Recall Information Bulletin

No: C1005110 **Issued:** 3/9/2012
NHTSA No: 12V-058
Transport Canada No: 2012-057
Re: Seat Belt Buckle
Group: 52 **Models:** FE

Safety Recall C1005110 - Seat Belt Buckle

FEC52, FEC72 and FEC92

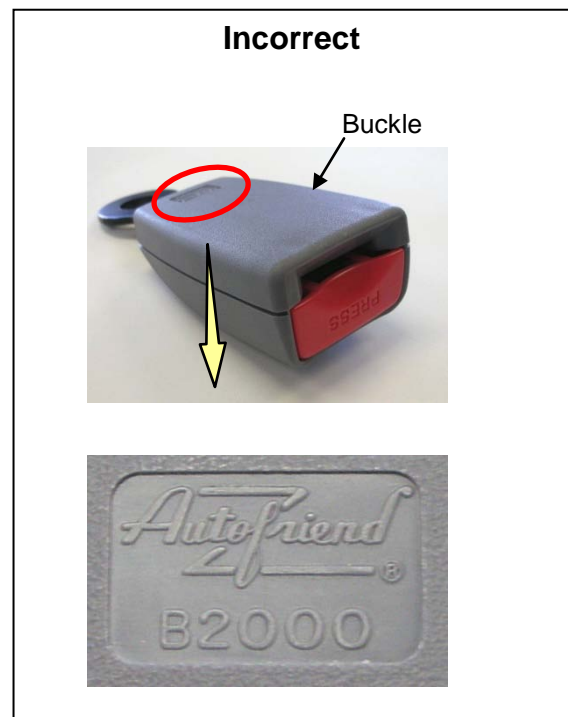
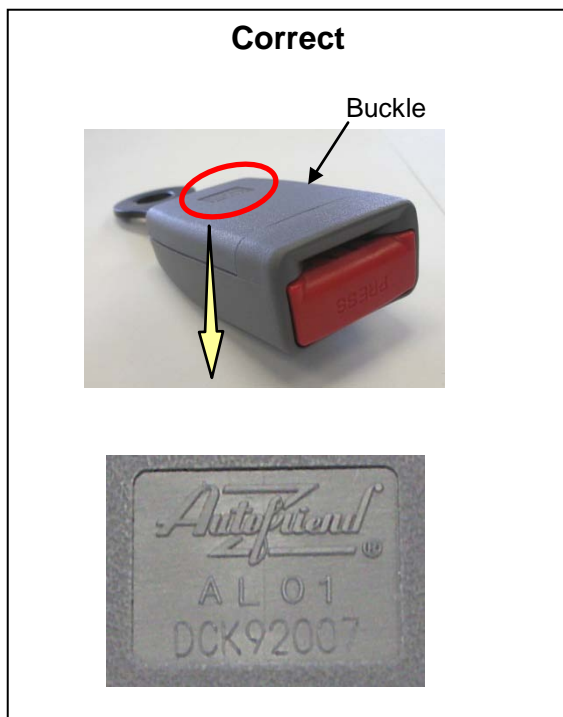
Inspect the model number stamped into the back of the passenger side seat belt buckle, as shown below. The correct buckle is stamped with model number “AL01”. The incorrect buckle is stamped “B2000”. If the correct “AL01” model seat belt is in place, skip to step 3.

A buckle stamped “B2000” must be replaced with part # **MK568854**. Replace the buckle with the correct model following the replacement instructions in the **2012 Canter FE/FG Service Manual, Group 52 Interior**.
